Consulting Arborist Services

Reference: Updated Tree Table and Tree Replacement  
– Response to Corrections

Site Address: 9167 SE 64th, Mercer Island 98040

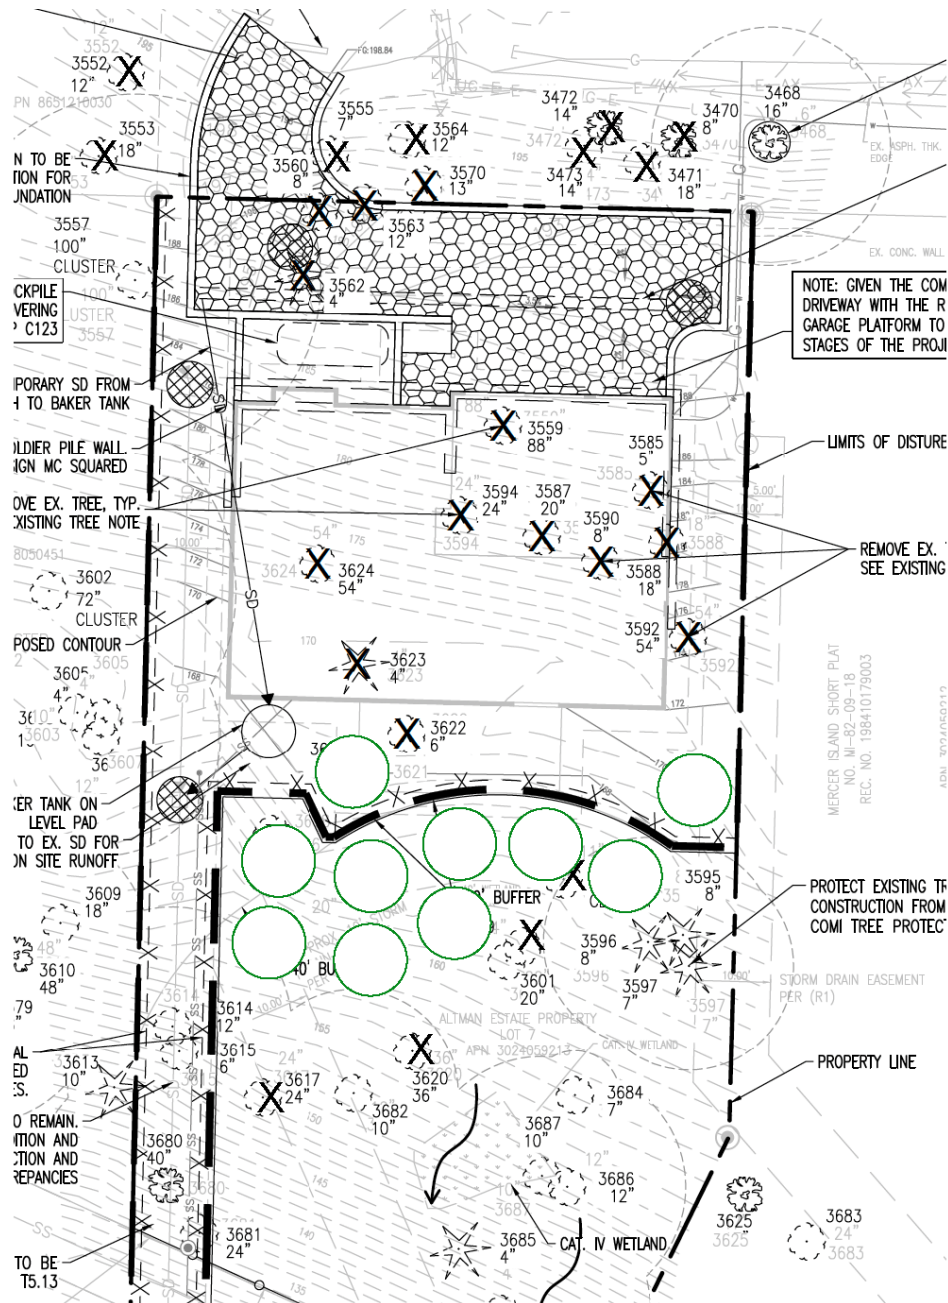
3. Sheet C1.0 and the tree replacement plan show different tree removals, especially on the ROW. All plan sheets, the tree inventory worksheet and arborist report must match with the tree removals. Tree 3570 is not listed as removed on the worksheet but is on the plans.

Tree retention and replacement numbers have been updated to reflect the original arborist report and the T.E.S.C. plan developed by Cecil + Associates, LLC, dated February 9, 2025. See the updated tree table which begins on Page 8 and annotations on Page 12. An updated Tree Submittal Checklist has been provided to the design team.

\*Project arborist shall be onsite for any activity or disturbance within the dripline of retained and protected trees, including installation of tree protection fencing and/or silt fencing. Some of these trees are located very close to the property boundaries where silt fencing is shown.
